**PLANNING COMMISSION
MEETING AGENDA
REGULAR MEETING**

September 26, 2023

SUBJECT: PUBLIC HEARING - SPECIAL USE APPROVAL AND PRELIMINARY SITE PLAN REVIEW (SU JPLN2023-0019) - Proposed Clean Express Car Wash, West side of John R, North of Fourteen Mile (PIN 88-20-35-401-001), Section 35, Zoned GB (General Business) District

Preliminary Site Plan For City of Troy, Michigan

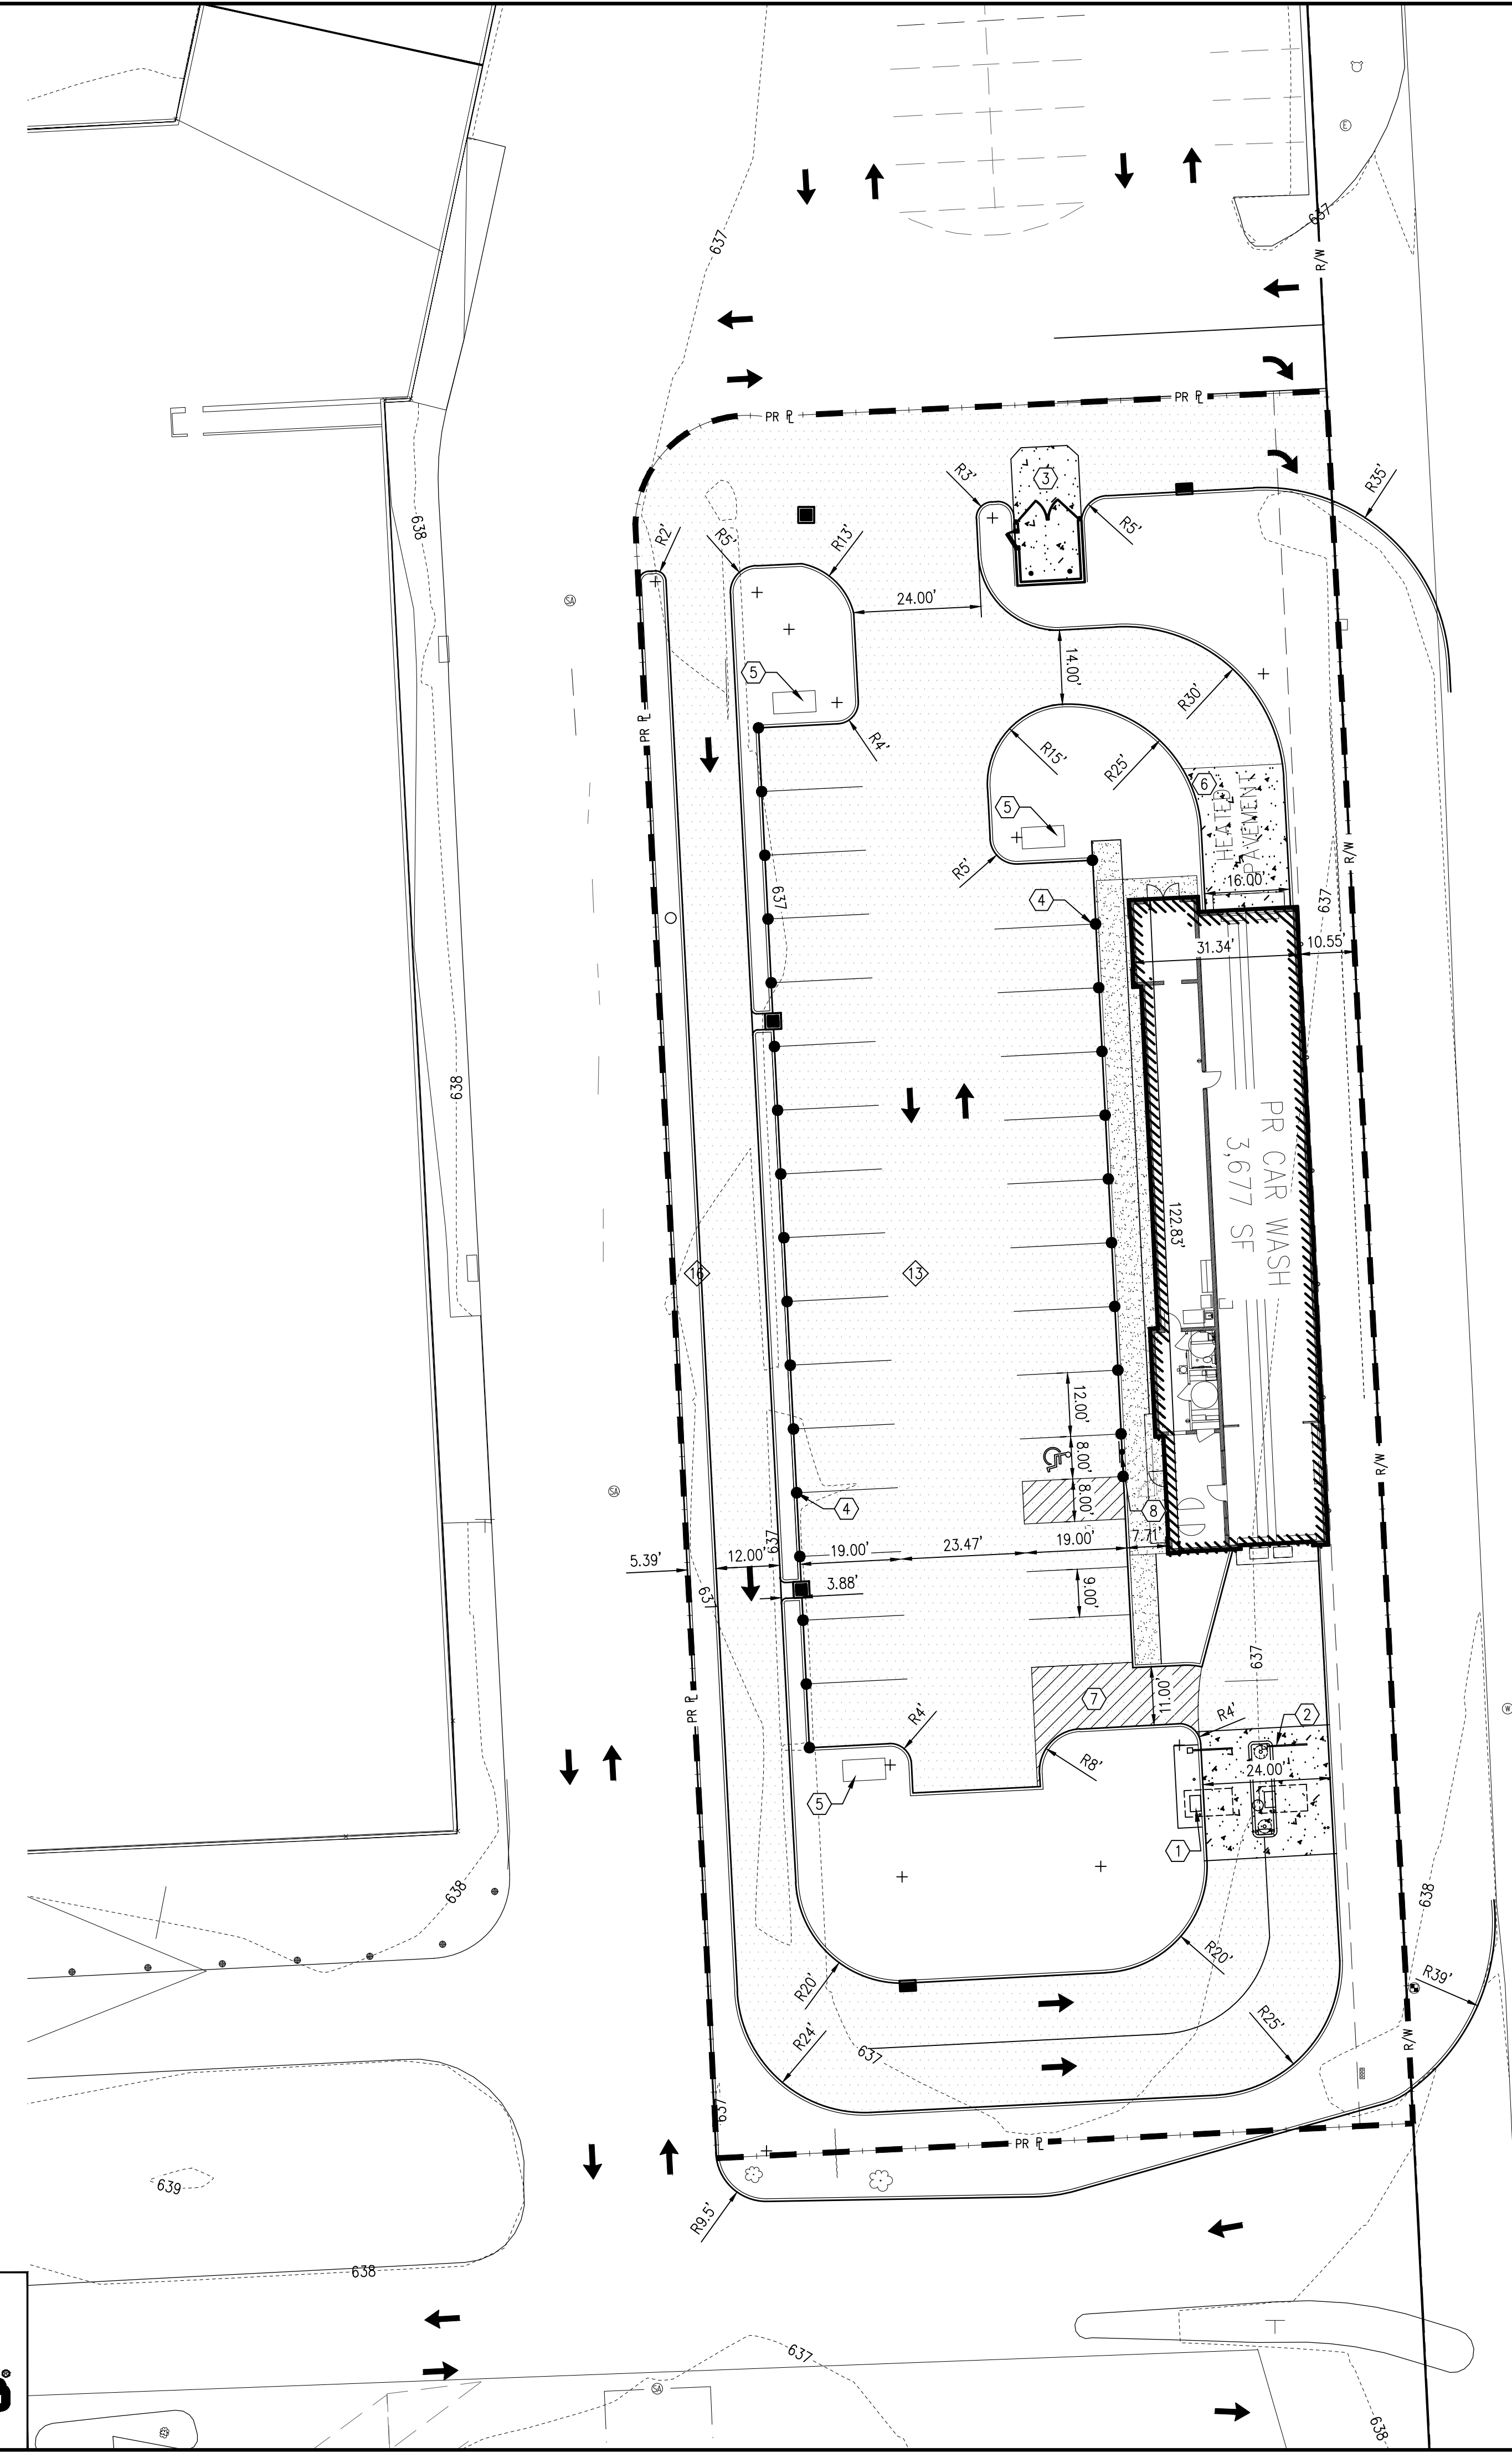
Required	Provided	Compliance
Car Wash	2 spaces, plus 12 stacking spaces per bay for a semi- or fully-automatic wash, 1 stacking space per bay for a self-serve wash, plus 1 space per 1 employee on the largest typical shift	26 vacuum spaces and 3 non-vacuum spaces. Over 12 stacking spaces.	Complies
Barrier Free	1	1	Complies
Bicycle Parking	2	0	Does not comply
Loading	0	0

The applicant is not providing any bicycle parking.

There are multiple points of access to the carwash area of the site via the exiting Oakland Mall parking lot. Direct access is from John R Road. There is a significant amount of traffic and circulation movement in the area of the direct entrance to the carwash and the access off John R Road. The Planning Commission should discuss with the applicant site circulation, especially around location of car wash entrance.

- 8-foot sidewalk required along John R Road
- Relocate dumpster, access from drive aisle not allowed.
- Provide sidewalk across the north side of lot, to and from John R

Items to be addressed: 1). The Planning Commission should discuss with the applicant site circulation, especially around location of parking lot entrance; 2). Provide 8-foot sidewalk required along John R Road; 3). Relocate dumpster, access from drive aisle not allowed; and 4). Provide sidewalk across the north side of lot, to and from John R Road.

Items to be Addressed: Provide bicycle parking.

1. Provide bicycle parking.
2. Provide 8-foot sidewalk required along John R Road.
3. Relocate dumpster, access from drive aisle not allowed.
4. Provide sidewalk across the north side of lot, to and from John R Road.
5. Add two (2) parking lot trees internal to the parking lot along the western parking area, and one (1) tree along the eastern parking lot area.
6. Stamp plan by licensed landscape architect.
7. Provide site specific 3-D model.

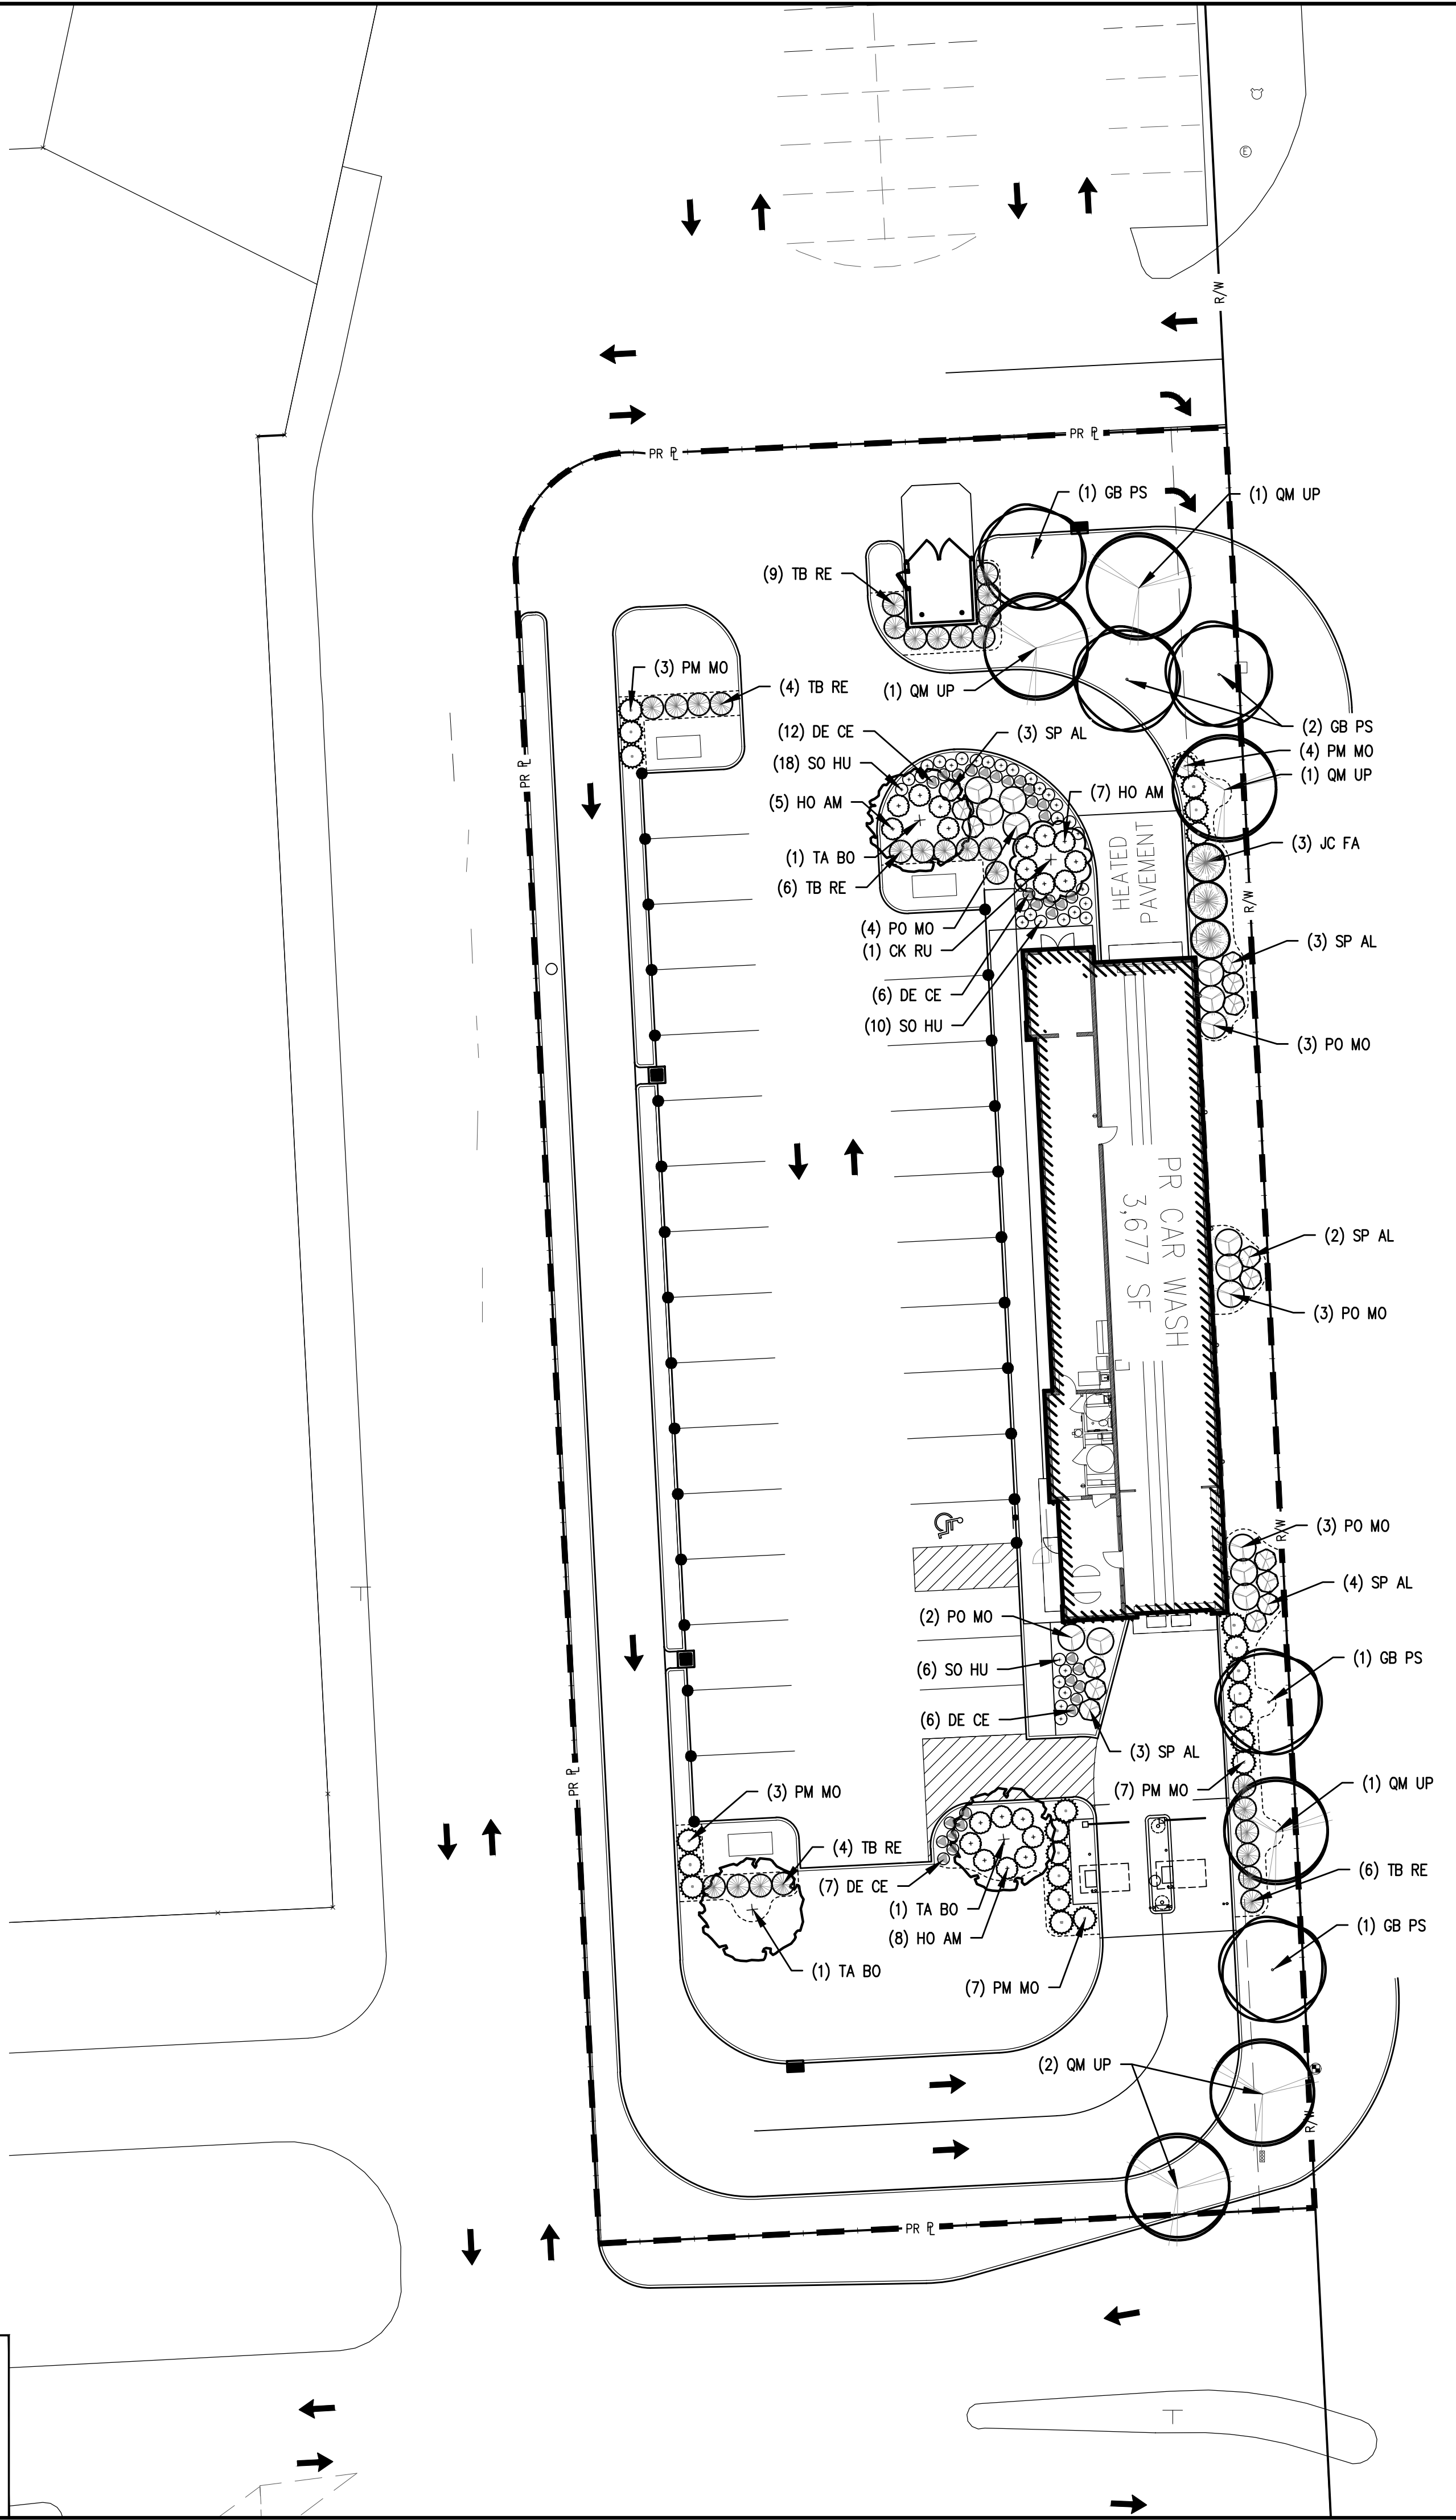
We note that there is a long stretch of parking (with vacuums) that does not have any parking lot landscaping. We recommend that the applicant provide two (2) parking lot trees internal to the parking lot along the western parking area, and one (1) tree along the eastern parking lot area. Parking lot trees in the western parking area will also breakup and help distinguish and define the property and use boundaries of the carwash.

It will require the loss of at least three (3) parking/vacuum space area. Landscape Plan was not stamped by a licensed landscape architect.

Items to be Addressed: 1). Add two (2) parking lot trees internal to the parking lot along the western parking area, and one (1) tree along the eastern parking lot area; and 2). Stamp plan by licensed landscape architect.
